REACTOR TRIP SYSTEM INSTRUMENTATION TRIP SETPOINTS

POWER DISTRIBUTION LIMITS

3/4.2.2 HEAT FLUX HOT CHANNEL FACTOR- $F_Q(X,Y,Z)$

Figure 3.2-1 Flow vs. Power for 4 Loops in Operation

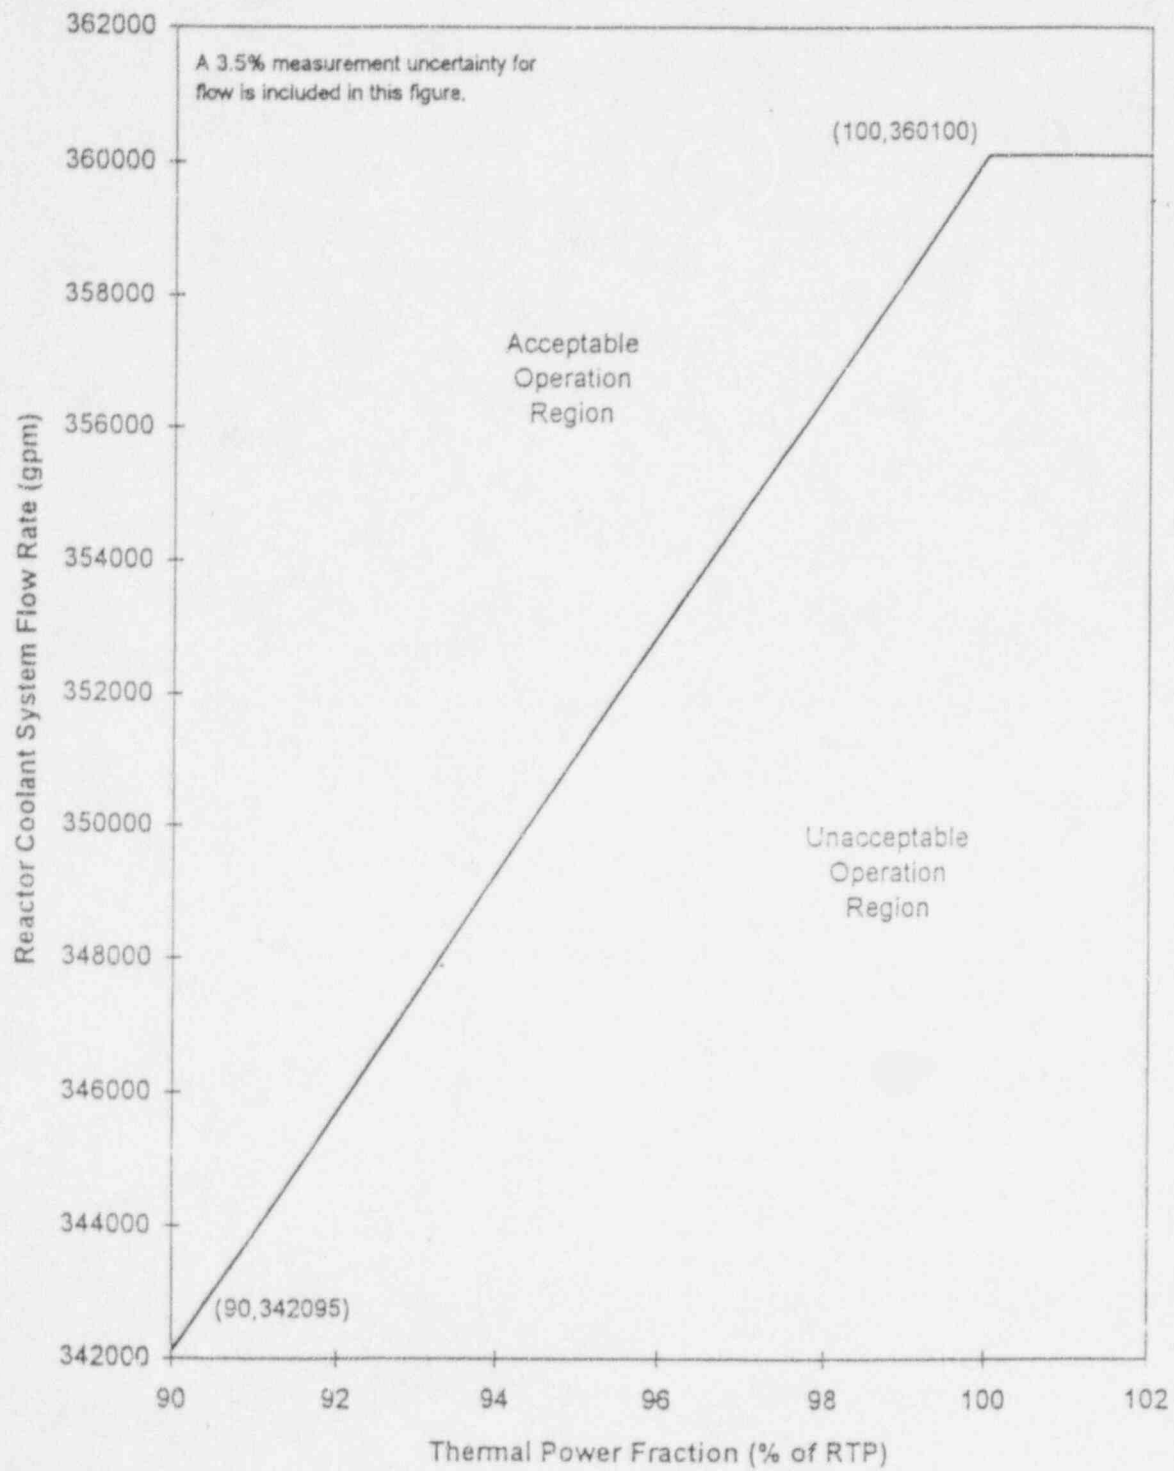
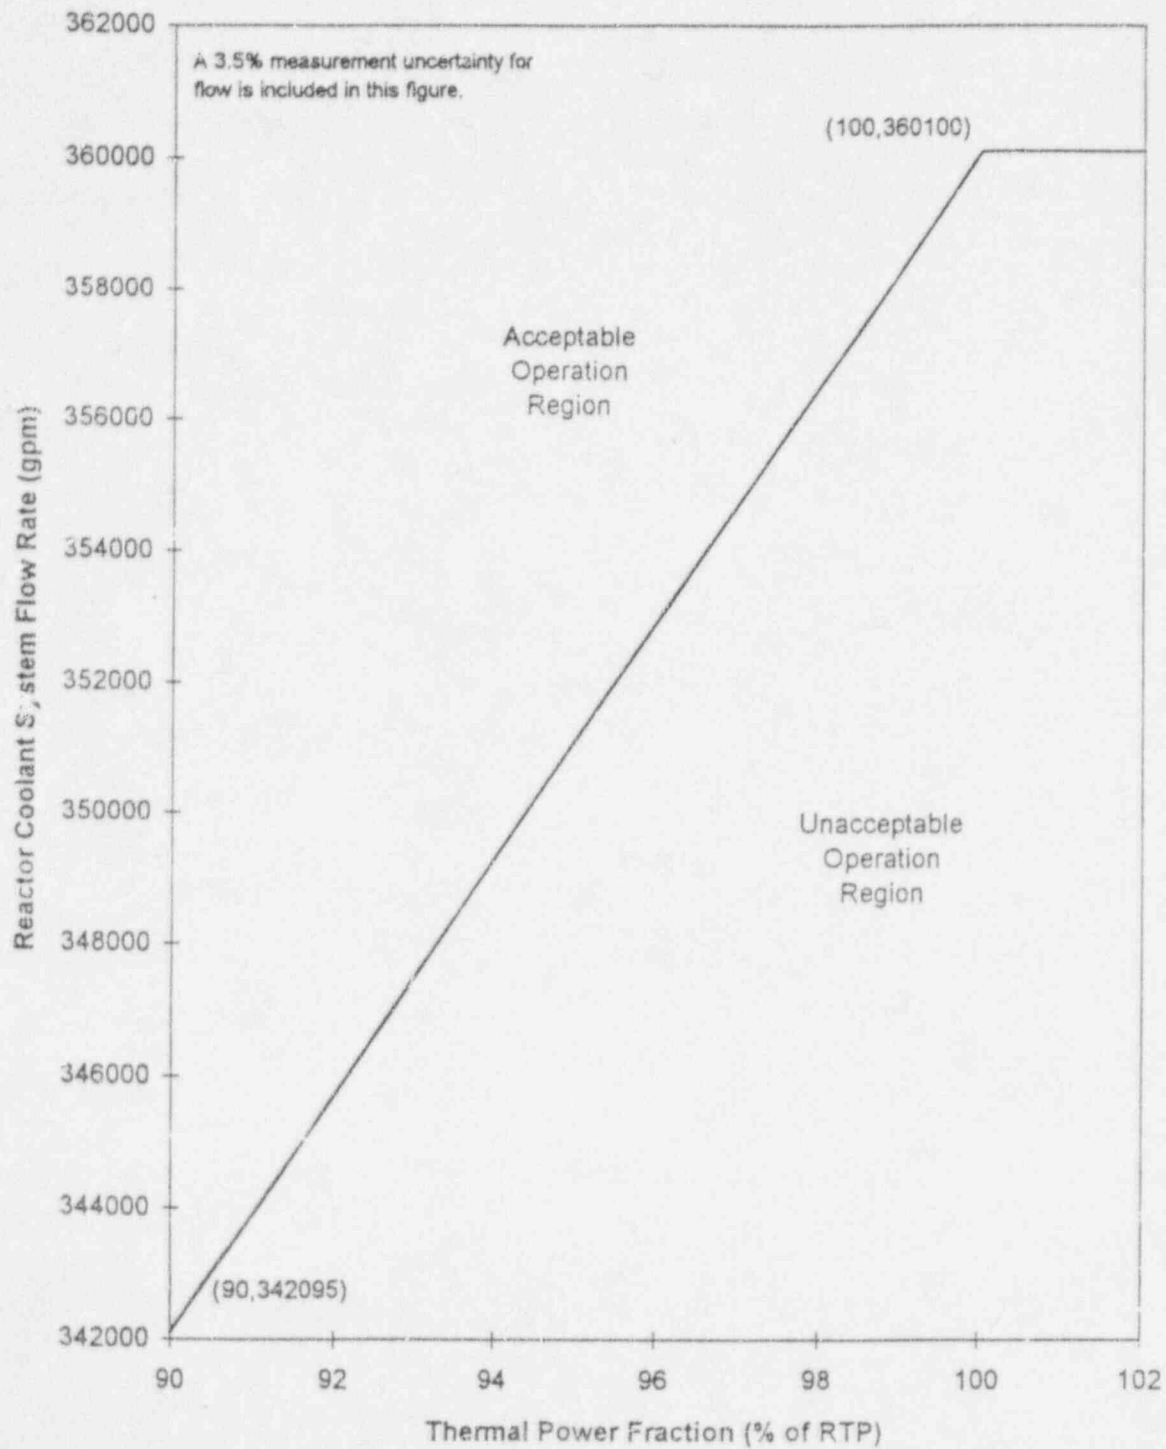
<u>PARAMETER</u>	<u>LIMITS</u>
	<u>4 Loops In</u> <u>Operation</u>
Reactor Coolant System T _{avg}	≤ 583°F
Pressurizer Pressure	≥ 2220 psia*
Reactor Coolant System	Figure 3.2-1
Total Flow

The flow parameters indicated in Figure 3.2-1 have been rounded down to bias the analysis in the conservative direction.

<u>PARAMETER</u>	<u>LIMITS</u>
	4 Loops In Operation
Reactor Coolant System T _{avg}	≤ 583°F
Pressurizer Pressure	≥ 2220 psia*
Reactor Coolant System Flow Rate	Figure 3.2-1

The flow parameters indicated in Figure 3.2-1 have been rounded down to bias the analysis in the conservative direction.
